**Second
Five-year Review Report**

**Valley Park TCE Site
Valley Park
St. Louis County, Missouri**

September 2008

**Region 7
United States Environmental Protection Agency
Kansas City, Kansas**

FIGURE 12. MAP OF GROUNDWATER CONTAMINANT CONCENTRATIONS ON

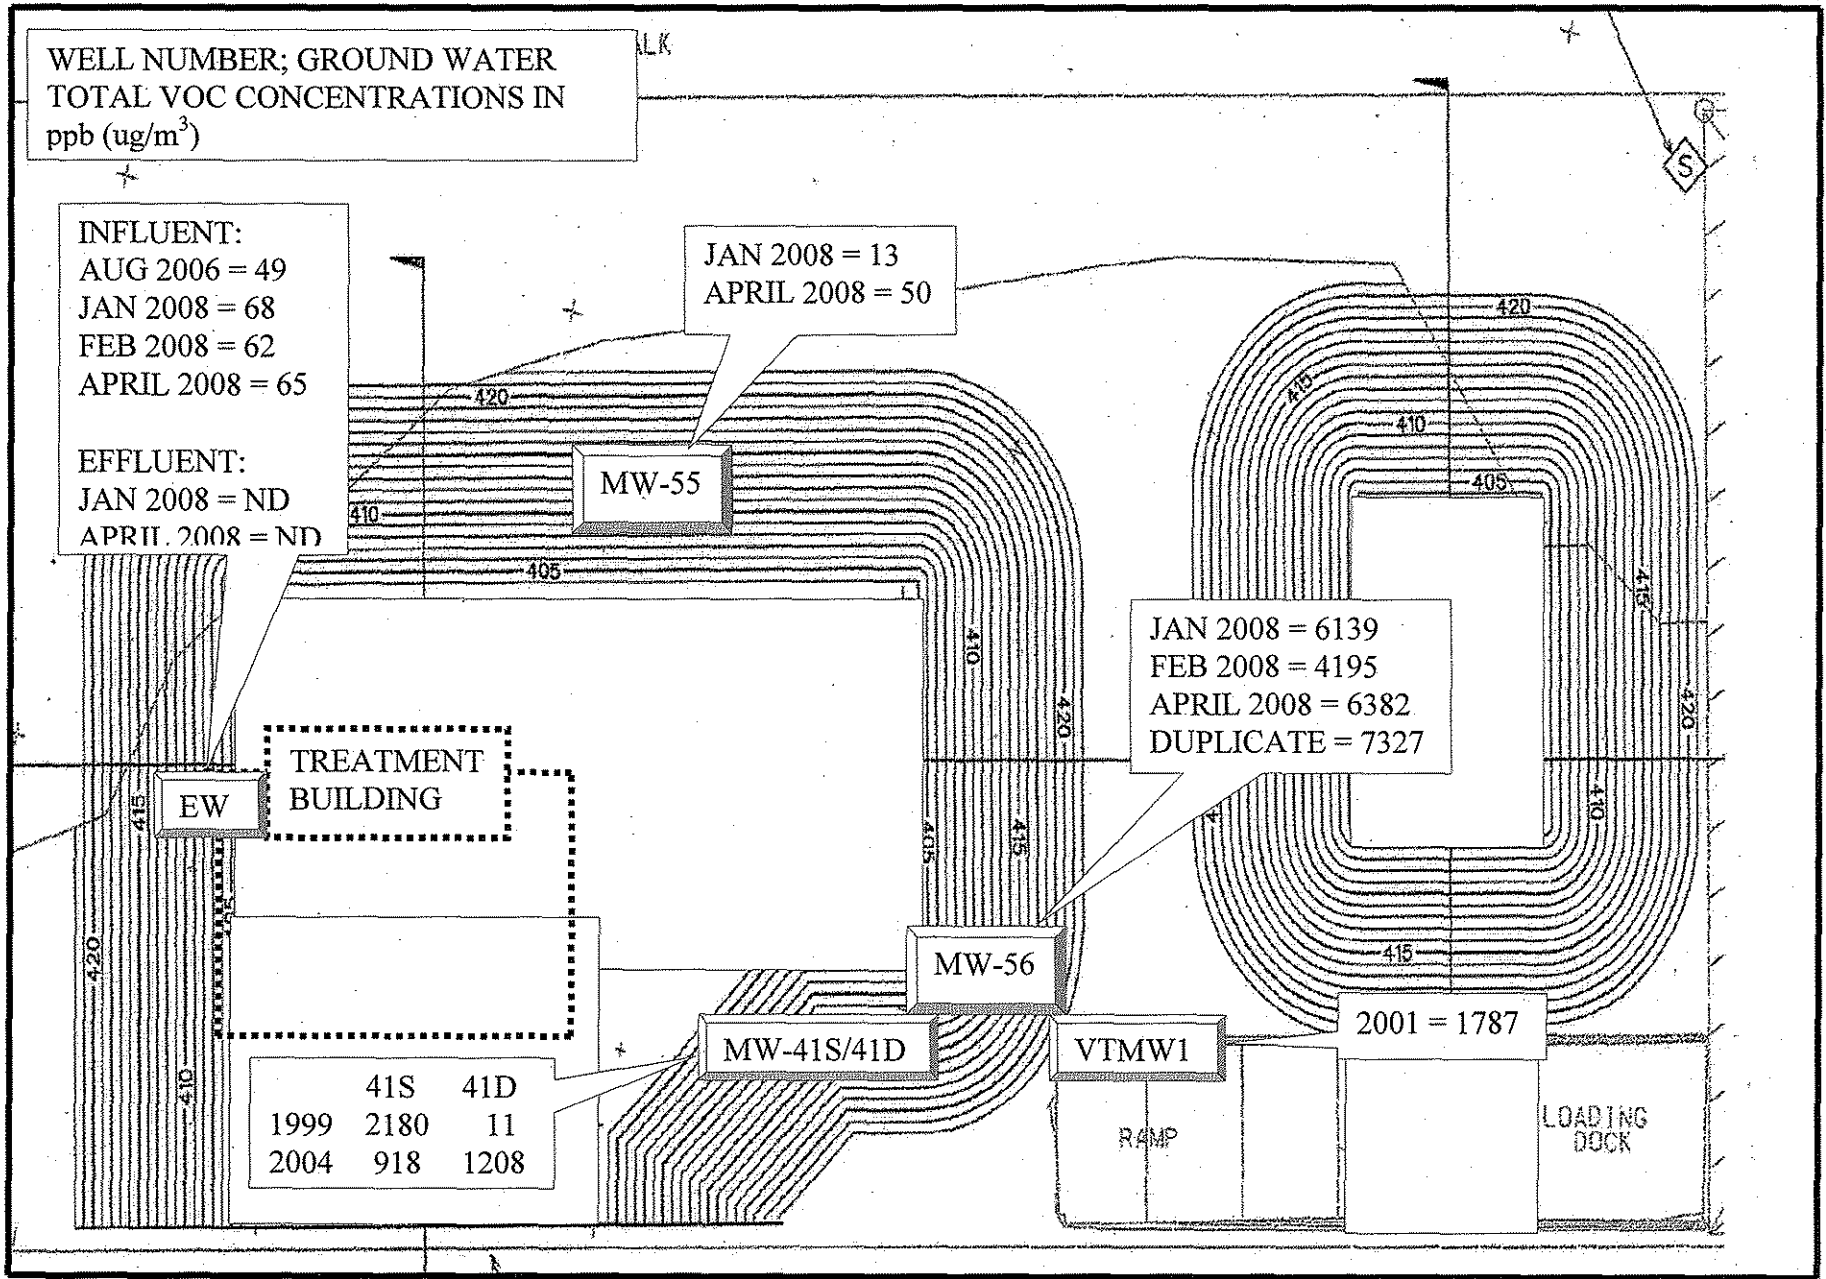
- Figure 12 presents the groundwater data for the monitoring wells located on OU2 source area (MW55 and MW56). In addition, data for three historic wells are presented for comparison purposes. Contaminant concentrations in MW55 are much lower than in MW56. Again, the April 2008 concentrations are higher than the January 2008 concentrations due to the high water conditions. The contaminant concentrations in MW56 are in the 6,000 ppb range, and this level is higher than expected. In comparison, the historic wells and corresponding data averaged 2,000 ppb total for VOCs. The soil excavation data do not indicate a soil source in that section of OU2 which would create the contamination level found in MW56. Thus, one of two explanations is possible: (1) the original plume migrated east and below the Valley Technologies' building, or (2) there is a soil source area below the Valley Technologies' building which was not found previously.

OU2 – Investigate source of high levels of contamination in MW56 if the levels do not significantly decrease in 2008.

FIGURE 13. AMBIENT AIR SAMPLING MAP for OU2

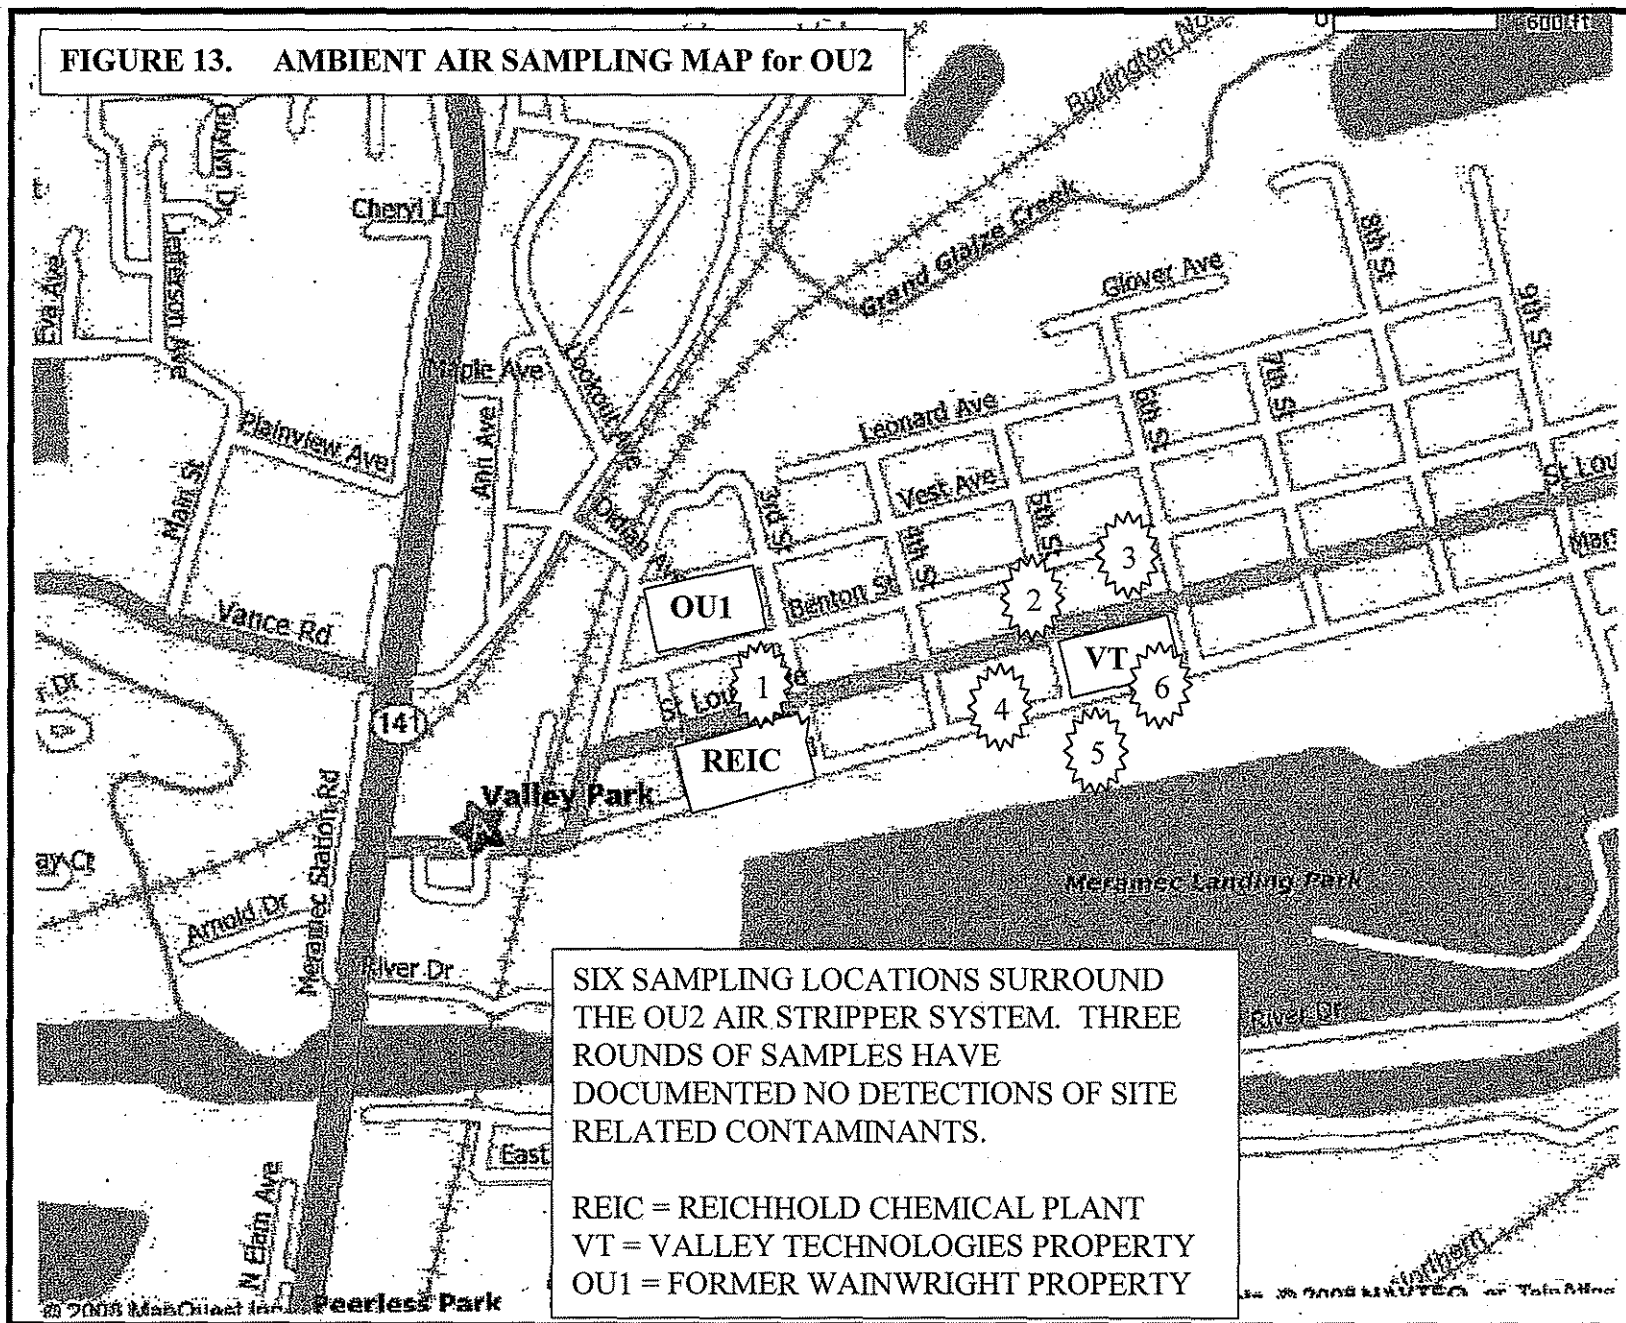
- Figure 13 presents the six sampling locations which have been sampled twice since January 2008. No Site contamination has been detected. Certain phenolic compounds have been detected which are suspected to originate from the Reichhold facility.

SIX SAMPLING LOCATIONS SURROUND THE OU2 AIR STRIPPER SYSTEM. THREE ROUNDS OF SAMPLES HAVE DOCUMENTED NO DETECTIONS OF SITE RELATED CONTAMINANTS.
